Product/Process Change Notice (PCN)

PCN #: PCN_WE-TIx_20141211

Product Affected: WE-TI & WE-TIS series

PCN Date: 11th of December 2014

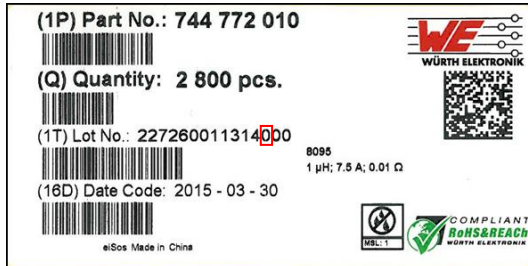
- 3.) Both inkjet and pad printing will be used from now on.

Inkjet Printing: Used for high quantity lot sizes

Pad Printing: Used for smaller quantity lot sizes
